Location of Construction: 856 Brighton Ave	Owner: The Breakwater School	Phone: 772-8689	Permit No: 981252
Owner Address:	Lessee/Buyer's Name:	Business Name:	Permit Issued NOV 2 1998 CITY OF PORTLAND Zoning Approval: 259-2-1
Contractor Name: The Thaxter Co.	Address: 55 Bell St Ptd, ME 04103	Phone: 878-5553

RE: Breakwater School - 856 Brighton Avenue

PROJECT
Breakwater School
856 Brighton Avenue
Portland ME 04102

Addendum

TITLE
Coping Detail, Typical

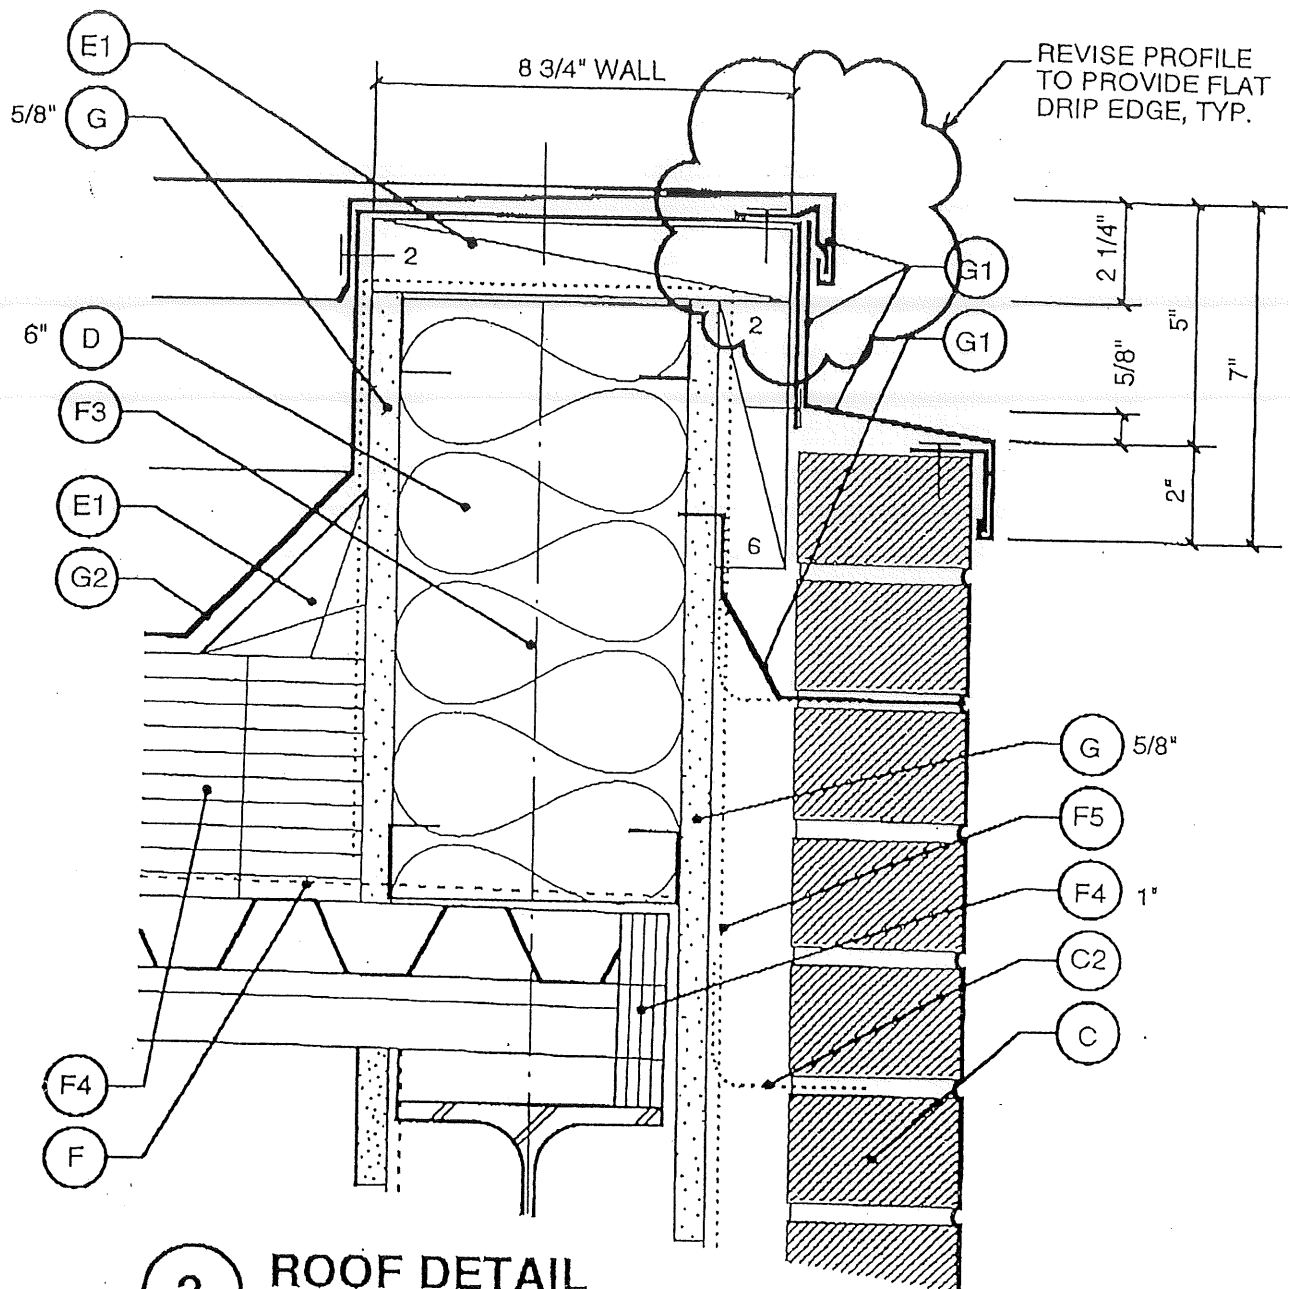
2-D1	A1.1	1	Change 7'-0" partitions in Kindergarten rooms L02 and L06 to 4'-0" partitions with wood tops as per SK-2.
3-D1	A1.1,2,3	1	18" dia. surround at column D2 shall be painted plaster finish, typ.
4-D1	A1.4	2,3,4	Change coping drip edge as per SK-1.
5-D1	A-2.2	Section 1	At Note: "Existing window to remain," Add "Paint exterior of existing window in New Common L01, M01, and U01."
6-D1	A-3.1	1, 2, 3 & 4	At Structural gravel below slab (A2) change dimension from 4 inches to 12 inches of depth.
7-D1	A-3.2	1, 2, & 3	At Structural gravel below slab (A2) change dimension from 4 inches to 12 inches of depth
		4	Delete note: (A2) 4" Typ.
8-D1	A-4.1	10	Change E5 (Beaded Plywood) reference to G3 (Metal Roofing) at exterior of wall.
		21	Add Note: "Metal roofing to cover all edges of plywood sheathing. Return into joint to a depth of 1 inch."
		24	At exterior of building change note from G3 (Metal Roofing) to E4 / L1 (Wood Siding #2, Painted)

TITLE
Kindergarten Partial Walls

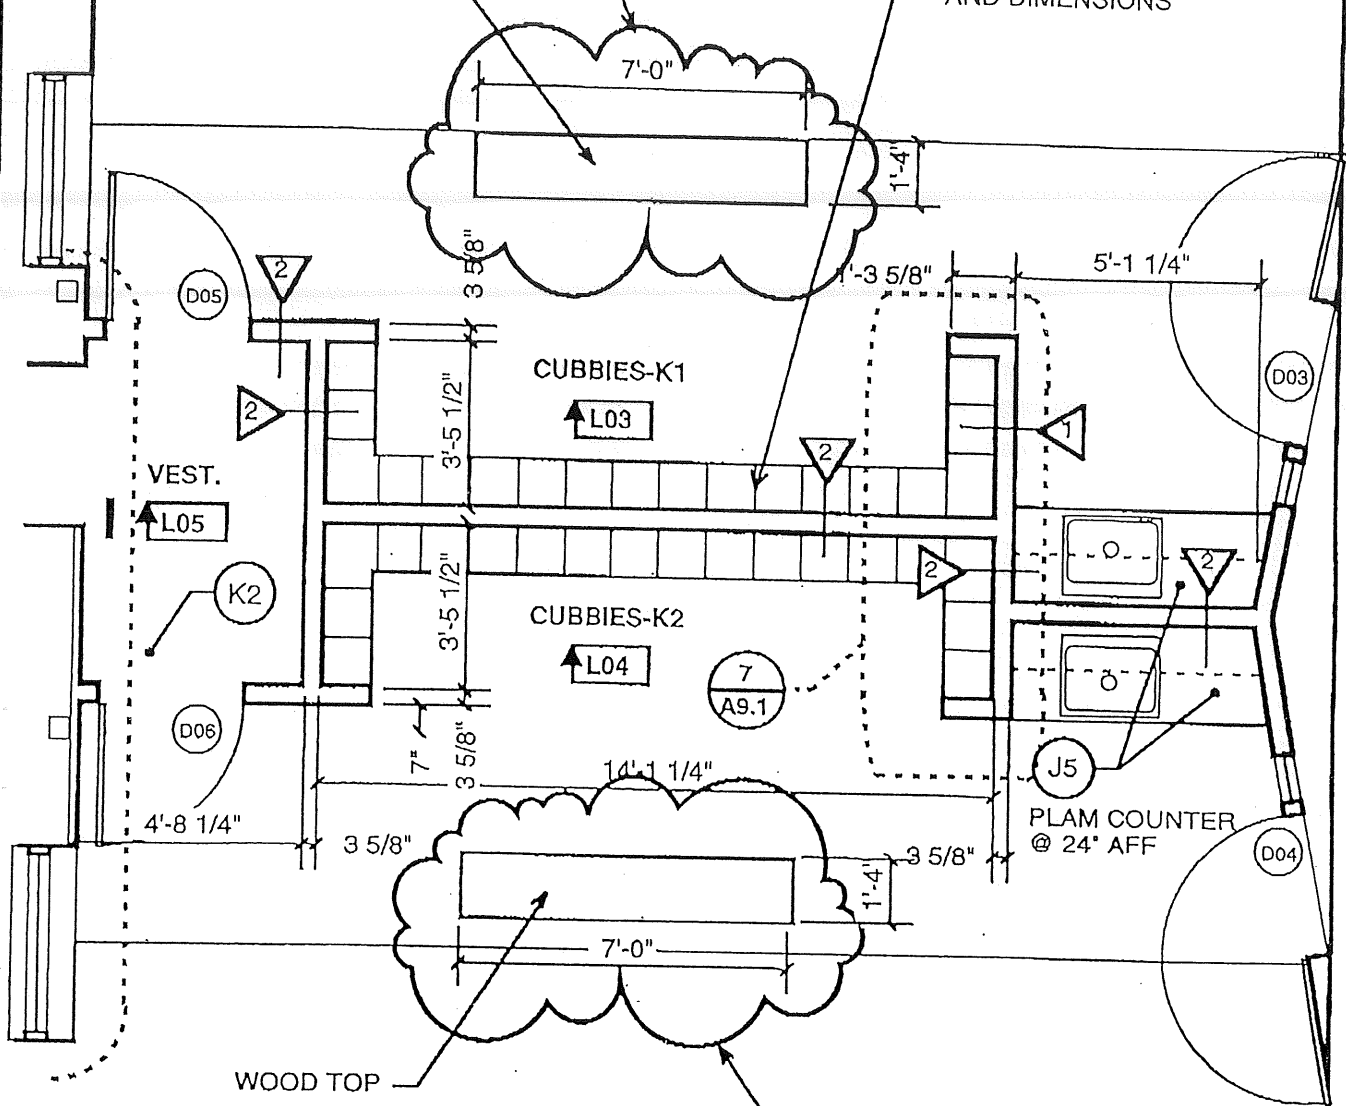
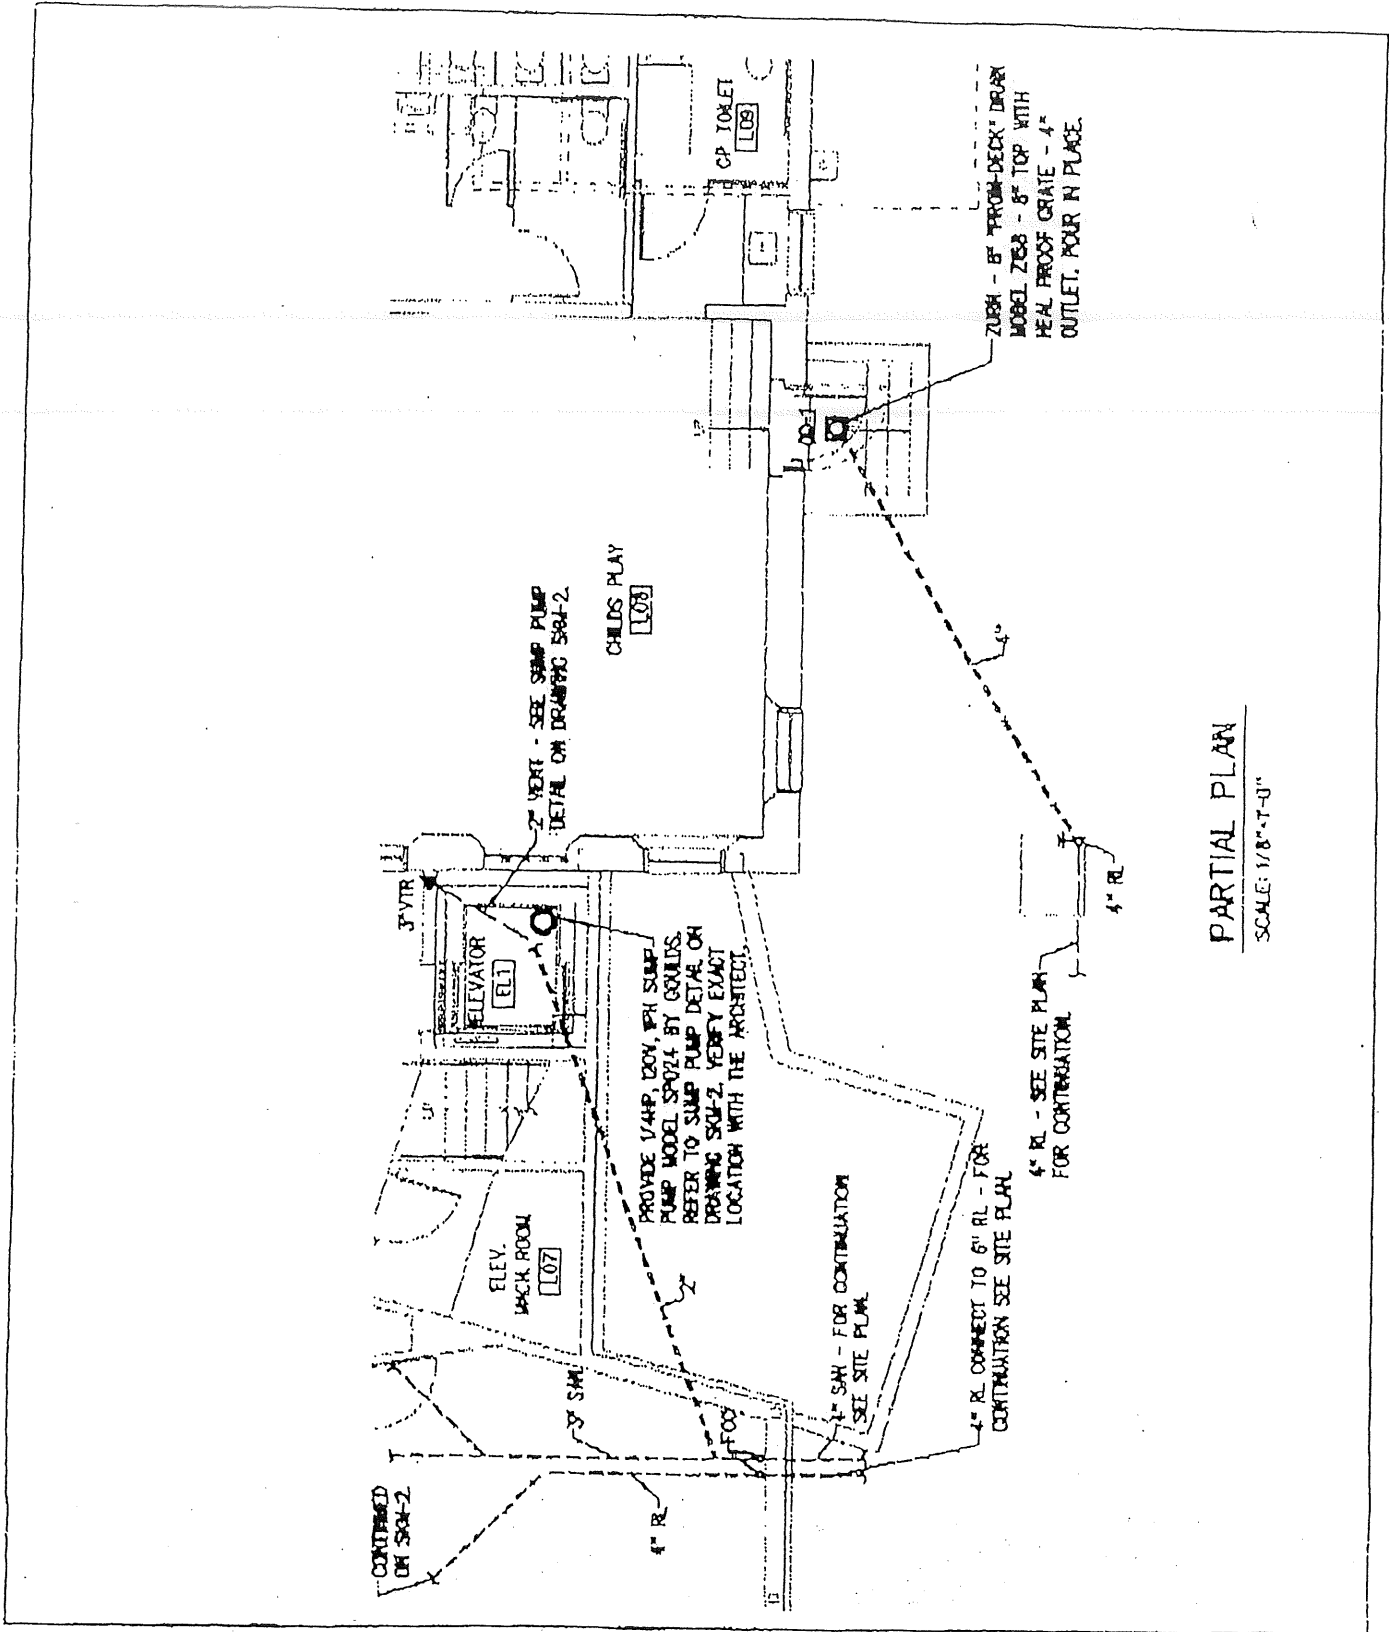
CHANGE 7'-0"H WALL TO LOW WALL W/ WOOD CAP. SEE A9.1 FOR SIM DETAILS AND DIMS.

CHANGE 7'-0"H WALL TO LOW WALL W/ WOOD CAP. SEE A9.1 FOR SIM DETAILS AND DIMS.

SUMP PUMP PIPING DETAIL
 NTS

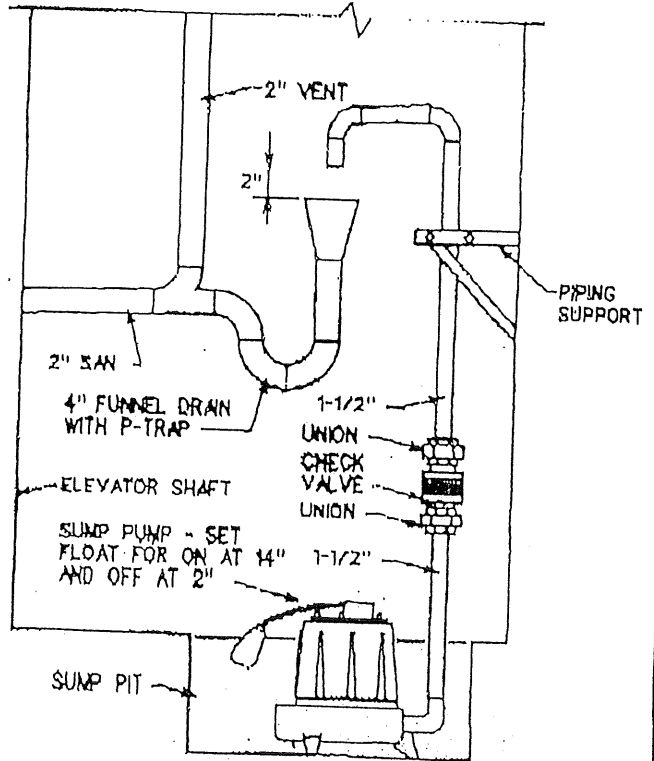
Add 2 inch drain line from elevator sump to connect to new 3" san. waste line at new addition. Provide and install sump pump. (See enclosed revision SKM-1)

Coping Detail, Typical

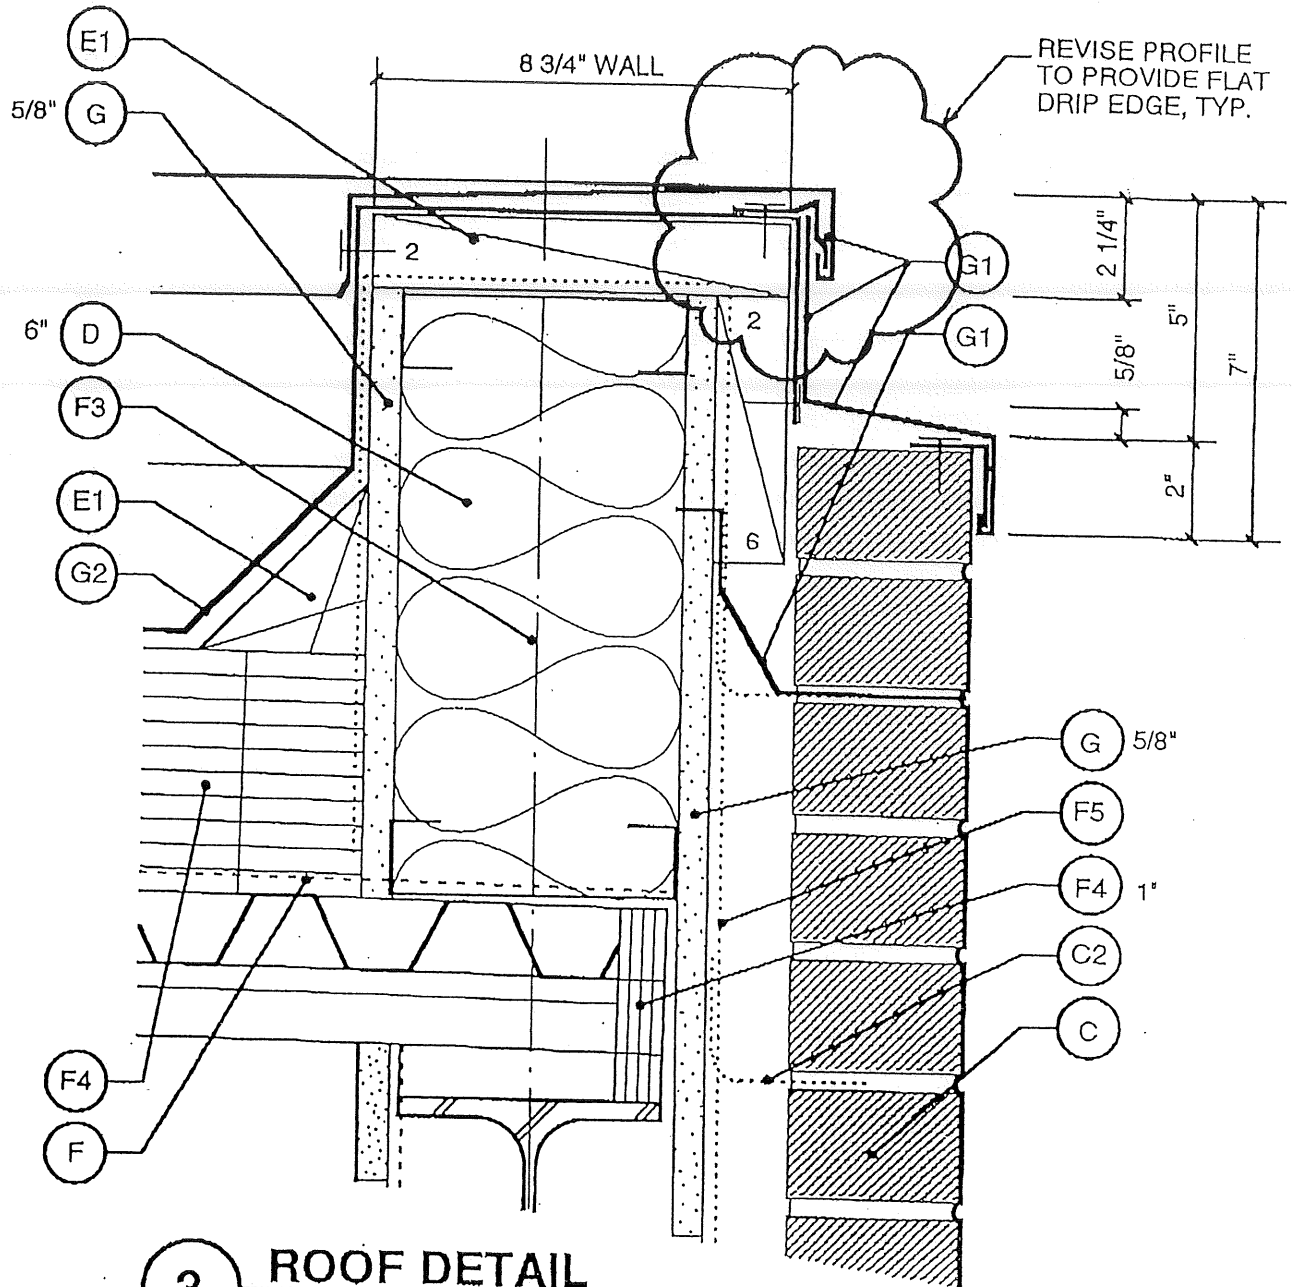
2-D1	A1.1	1	Change 7'-0" partitions in Kindergarten rooms L02 and L06 to 4'-0" partitions with wood tops as per SK-2.
3-D1	A1.1,2,3	1	18" dia. surround at column D2 shall be painted plaster finish, typ.
4-D1	A1.4	2,3,4	Change coping drip edge as per SK-1.
5-D1	A-2.2	Section 1	At Note: "Existing window to remain," Add "Paint exterior of existing window in New Common L01, M01, and U01."
6-D1	A-3.1	1, 2, 3 & 4	At Structural gravel below slab (A2) change dimension from 4 inches to 12 inches of depth.
7-D1	A-3.2	1, 2, & 3	At Structural gravel below slab (A2) change dimension from 4 inches to 12 inches of depth
		4	Delete note: (A2) 4" Typ.
8-D1	A-4.1	10	Change E5 (Beaded Plywood) reference to G3 (Metal Roofing) at exterior of wall.
		21	Add Note: "Metal roofing to cover all edges of plywood sheathing. Return into joint to a depth of 1 inch."
		24	At exterior of building change note from G3 (Metal Roofing) to E4 / L1 (Wood Siding #2, Painted)

TITLE
Kindergarten Partial Walls

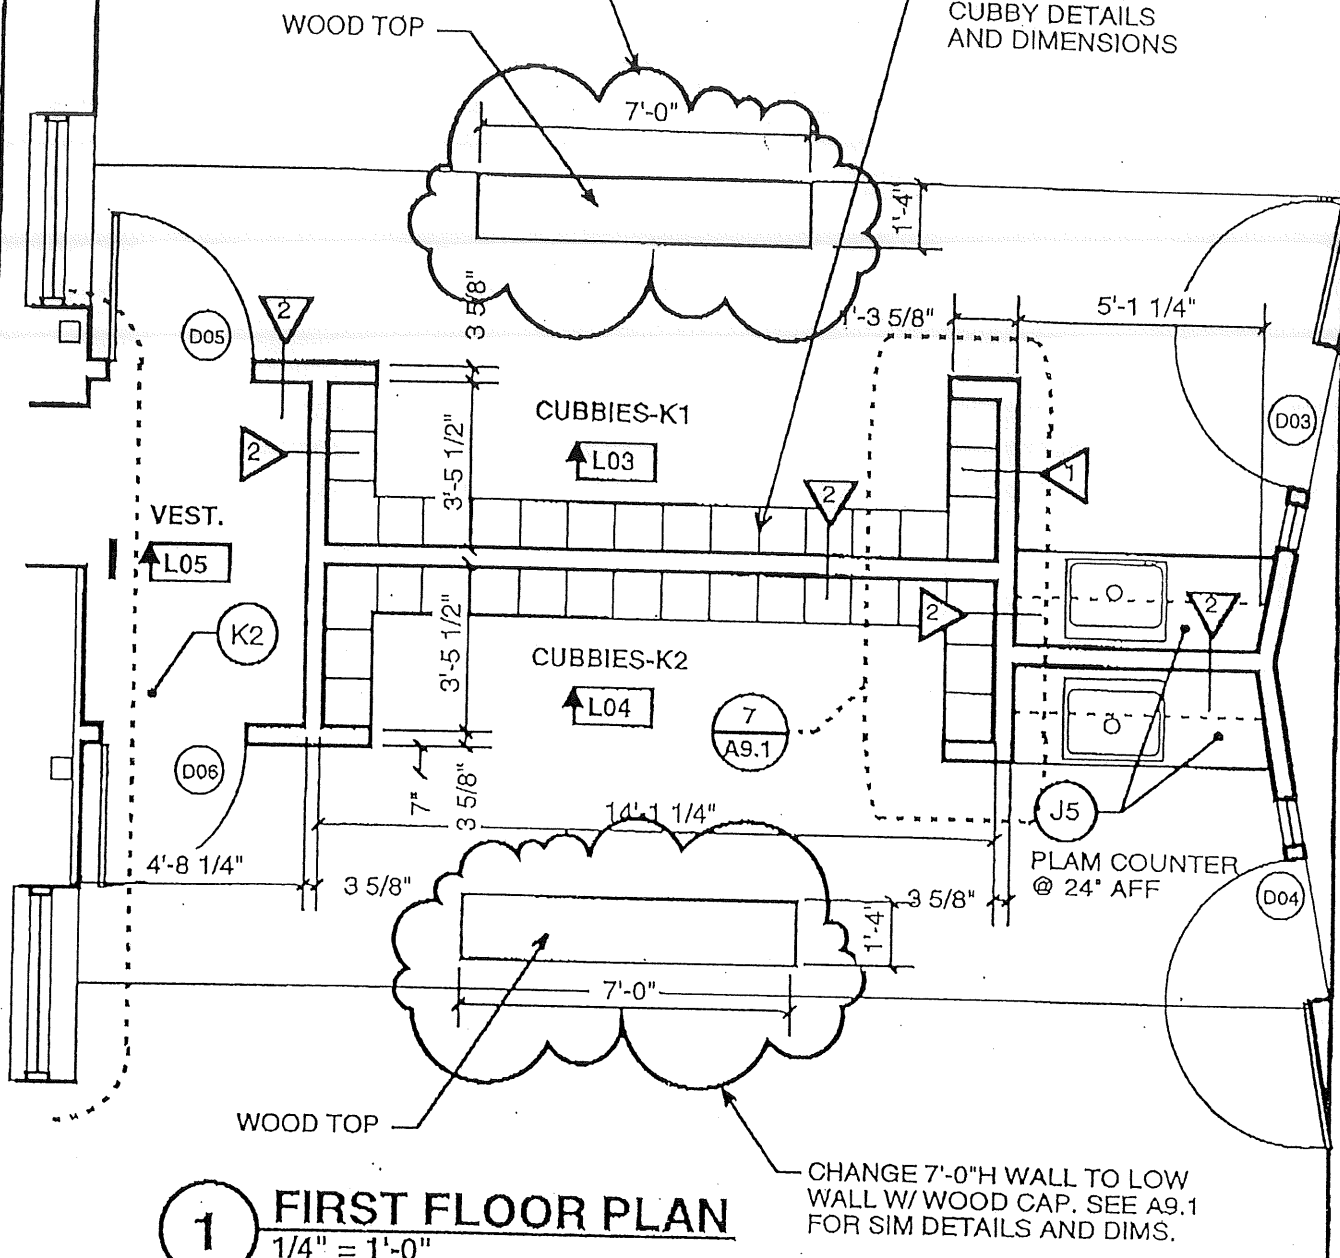
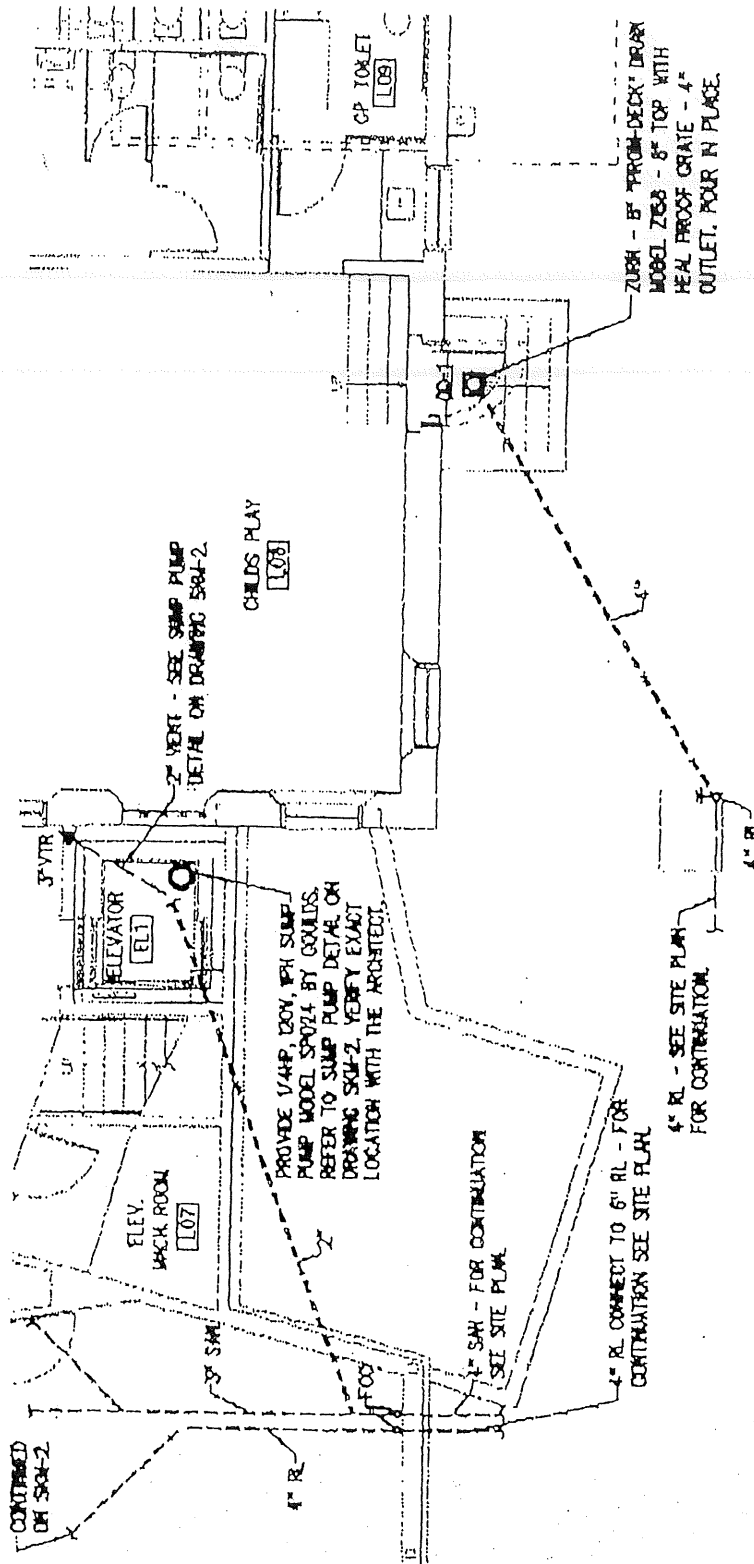
CHANGE 7'-0"H WALL TO LOW WALL W/ WOOD CAP. SEE A9.1 FOR SIM DETAILS AND DIMS.
